Docket Number:	17-BSTD-02
Project Title:	2019 Title 24, Part 6, Building Energy Efficiency Standards Rulemaking
TN #:	222835
Document Title:	The Greenheck Group Comments On Staff Supplement Variable Exhaust Flow Control
Description:	N/A
Filer:	System
Organization:	The Greenheck Group
Submitter Role:	Public
Submission Date:	3/2/2018 3:04:58 PM
Docketed Date:	3/2/2018

On Staff Supplement Variable Exhaust Flow Control

RE: Docket Number 17-BSTD-02; Staff Supplement Variable Exhaust Flow Control (TN#-222281)

Figure 1 – Installed Cost of a Factory Built vs. a Field Built High Plume Blower.

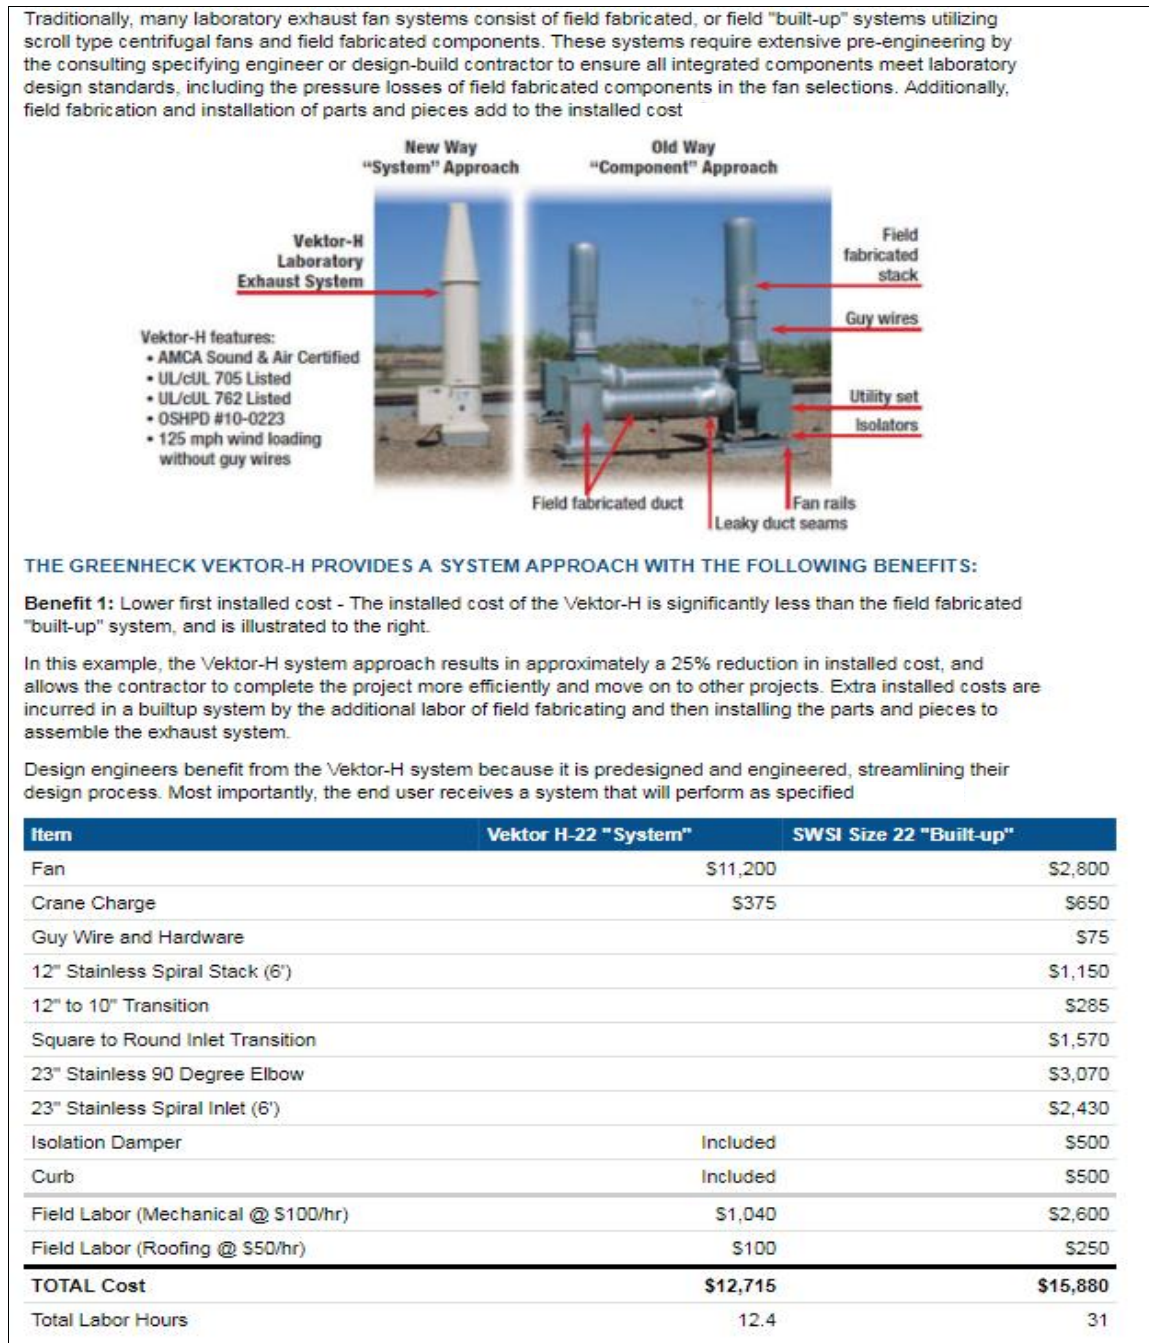
2. Cost Savings to Consumers – Due to the safety and liability issues stated above, there are many reputable manufacturers producing AMCA 260 licensed products at very cost effective prices. Products not AMCA 260 licensed must be field tested for performance verification to assure toxic fumes will not cause a safety issue to building or neighboring

buildings. The cost of field testing is usually much more expensive and subject to inaccuracies when compared to products that are licensed to AMCA 260. In addition, fans are often field assembled to meet requirements concerning health and safety. The cost of field assembly is far greater than fans tested and licensed to AMCA 260. Figure 1, while not a dilution fan, is a good reference for comparative costs between factory and field build high plume exhaust blower systems.
